### **Presentation from Northwatch**

#### **Bruce Power Inc. – Bruce A and B Nuclear Generating Station**

**Comment on the Application by Bruce Power Inc.  
(Bruce Power) to Renew its Power Reactor  
Operating Licence (PROL) for the Bruce Nuclear  
Generating Stations A and B**

Ref. 2018-H-02

# Irradiated Fuel Status 2013-2017

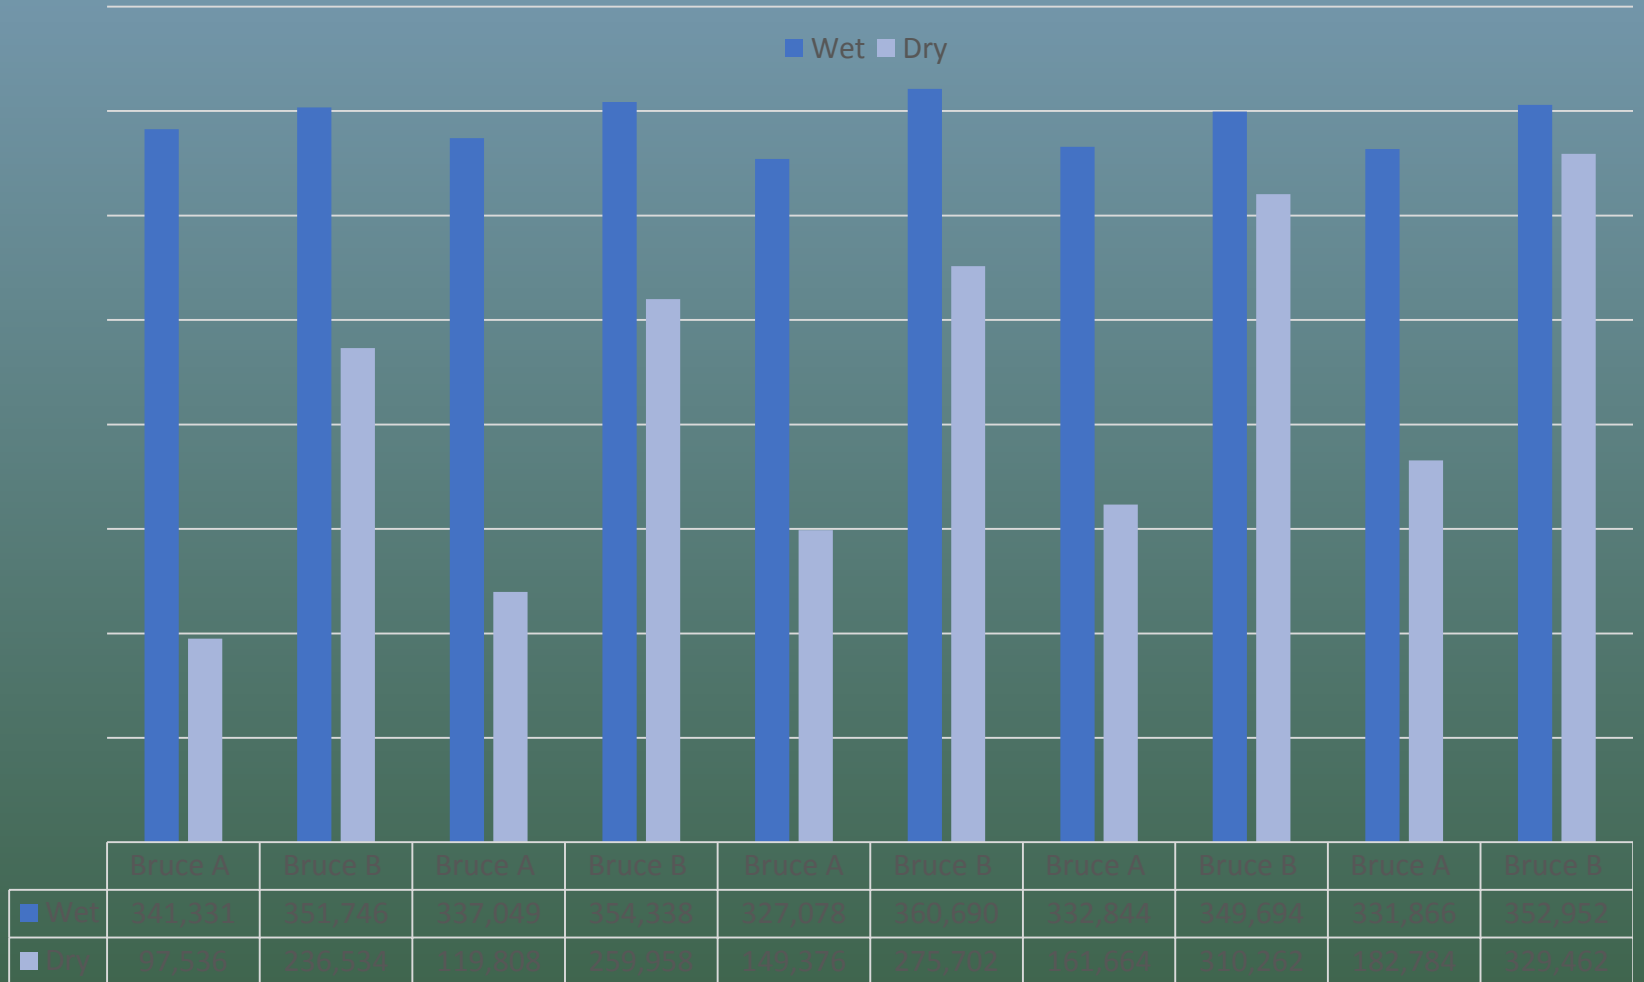
RECOMMENDATION: Require that the issue of **fuel defects** – and any other operational challenges that were initiated by the previous refurbishment activities – be fully understood and fully resolved prior to any additional refurbishment / Major Component Replacement campaigns be commenced.

RECOMMENDATION: Require Bruce Power to undertake a comprehensive assessment of the integrity and function of the **irradiated fuel bays**, including an analysis for the effects of aging and whether the existing structures are and/or will remain sufficiently robust over the proposed period of extended operations at Bruce NGS.
